November 20, 2018

**Re: McDonalds - 8315 Montgomery Blvd NE
Tract A-1-F of the Los Pastores Shopping Center
Grading and Drainage Plan - Engineer's Stamp dated: missing (F19D013A)**

RE: 8315 Montgomery Blvd. NE – HYDROLOGY COMMENTS

DESIGNED		MAR 2018		TJR	
DRAWN		MAR 2018		TJR	
CHECKED		04/04/2018		DWL	
AS-BUILT					
DRAINAGE CALCULATIONS					
C8.2

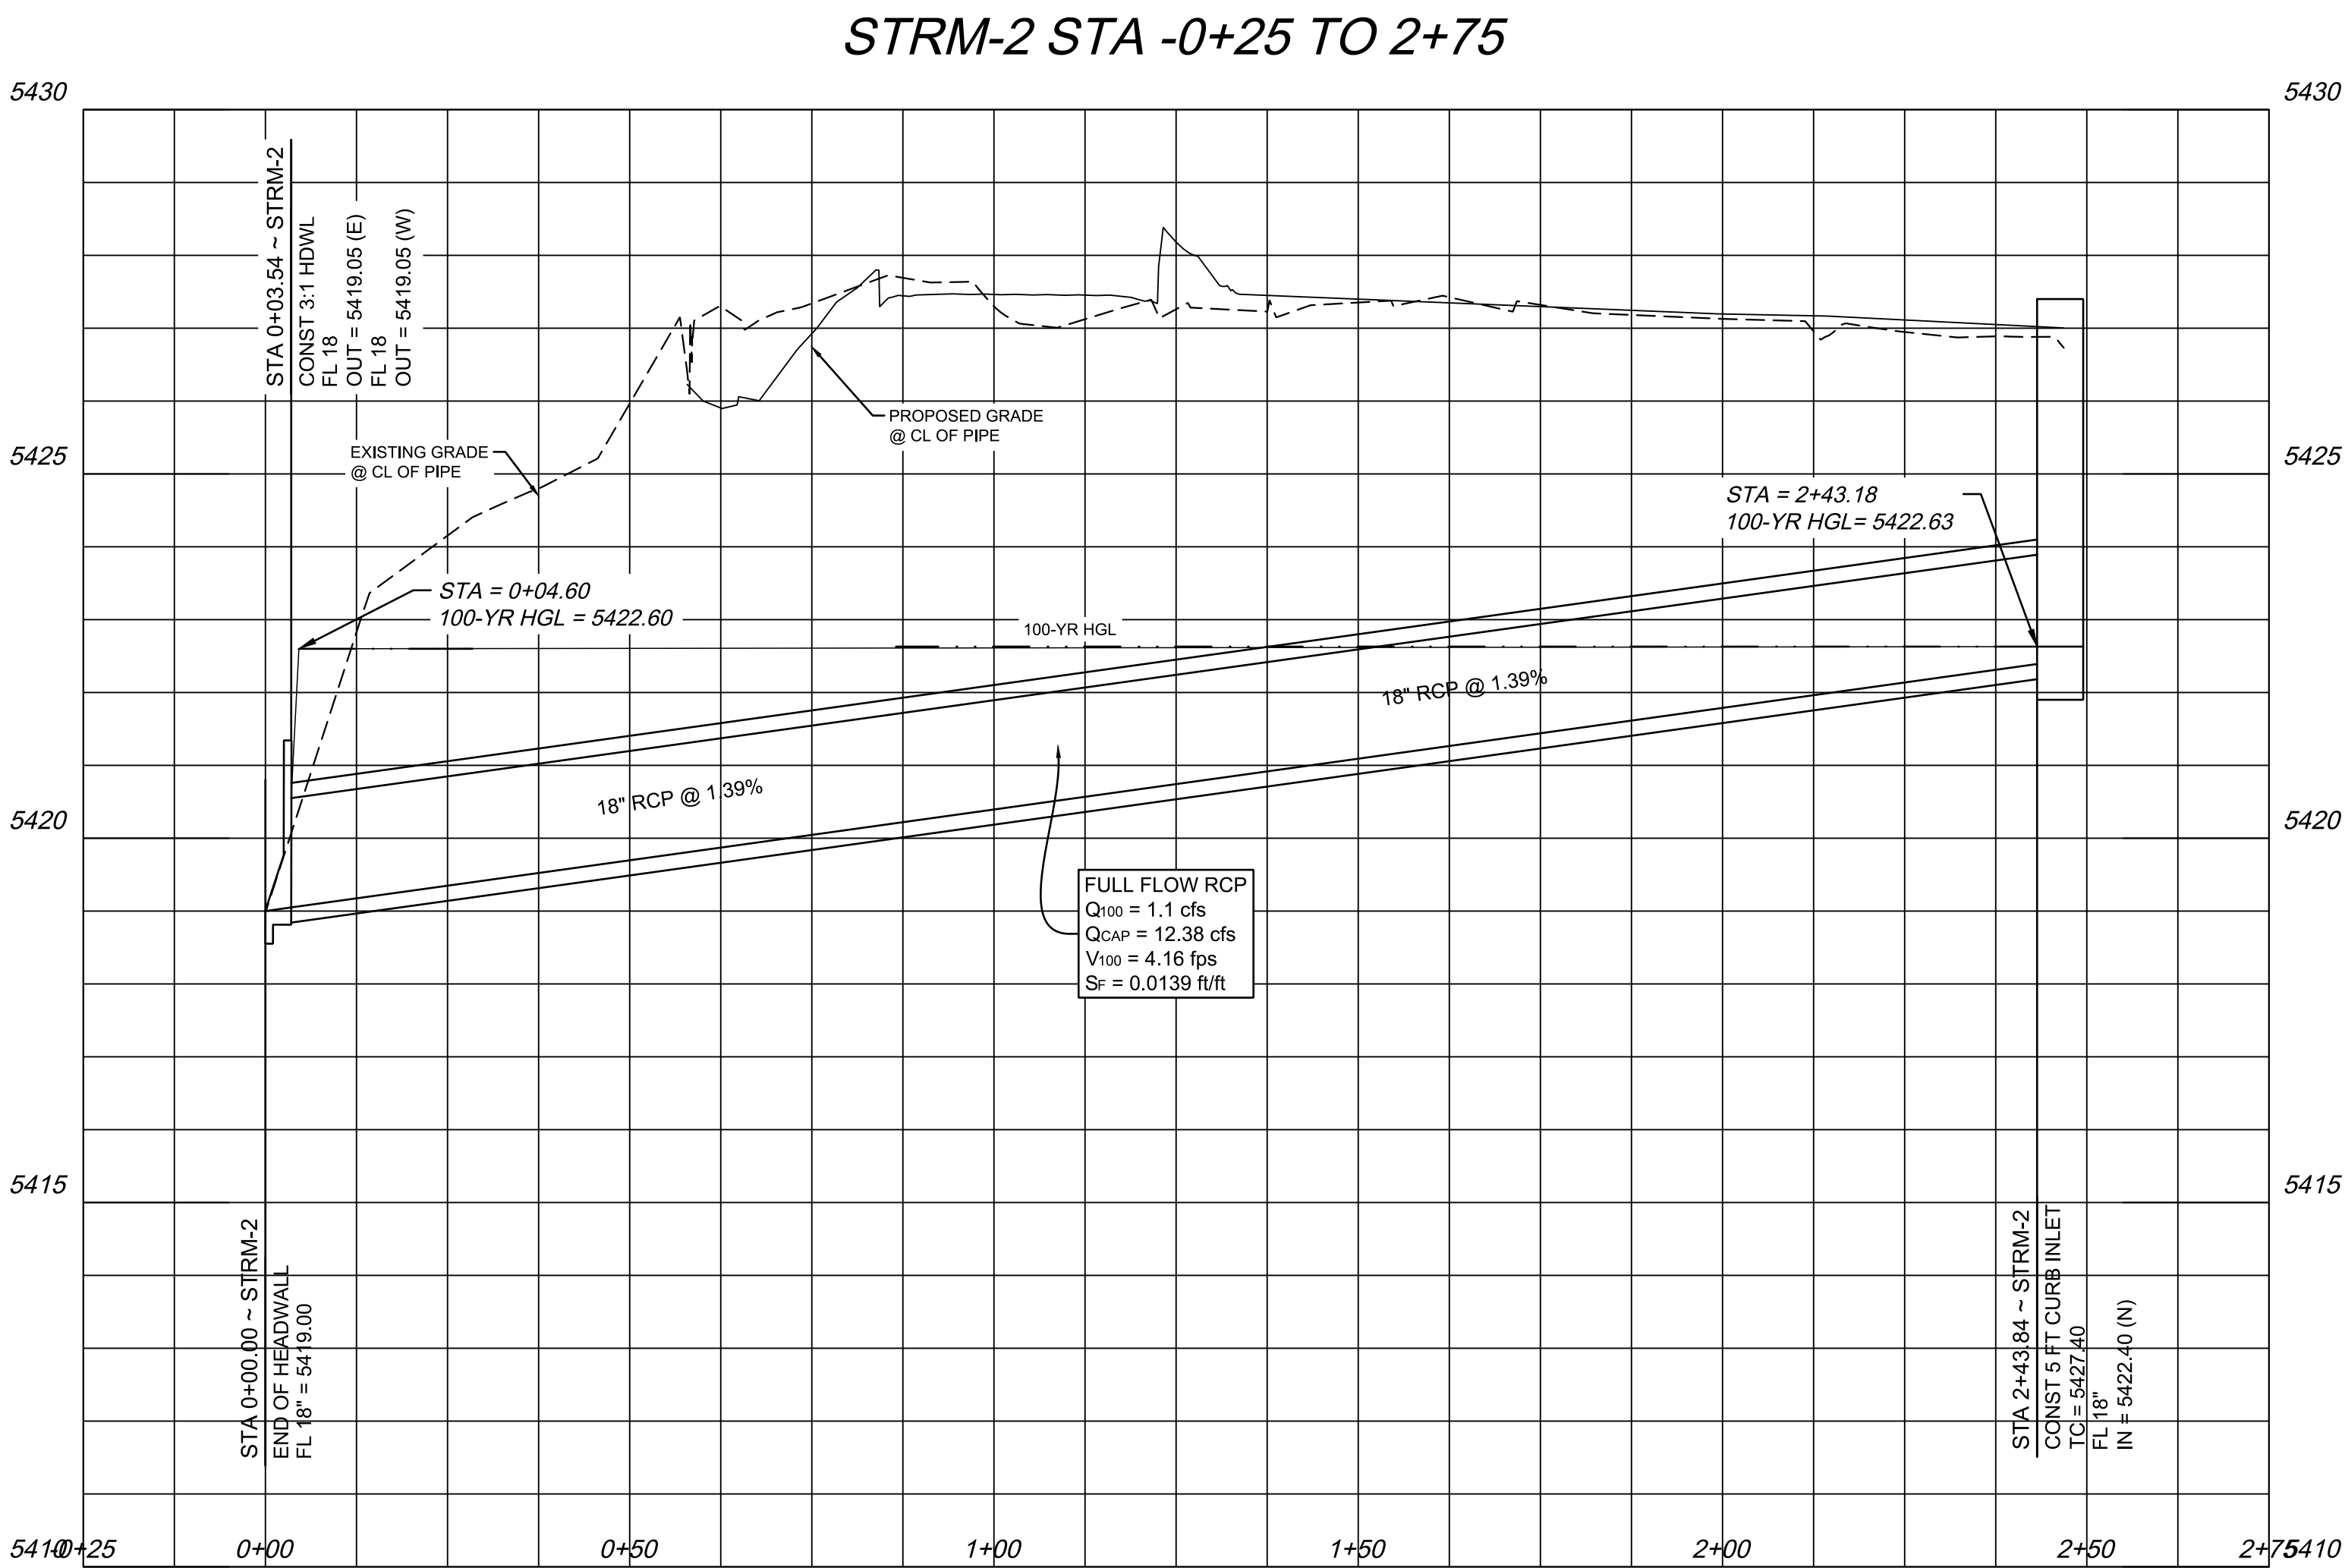
- 9) Details of each pond are required including typical sections, dimensions, and spot elevations. Volume calculations must be added to the plan for each pond based on the area of each contour using the conic method of volume calculations. **A typical pond section is shown on Sheet C8.2. Each pond has a horizontal dimension noted on Sheet C4.0 Site Plan, and spot elevations are shown on C7.0 Grading Plan. Volume calculations are tabulated on Sheet C8.2**

- 14) HGL calculations are required for the storm drain pipes and the HGL must be shown on a profile of each pipe specifying the pipe material, slope, invert elevations, and lengths, flow rate, and velocity. **Profile and HGL added for STRM-2. Calculations tabulated on Sheet C8.2**
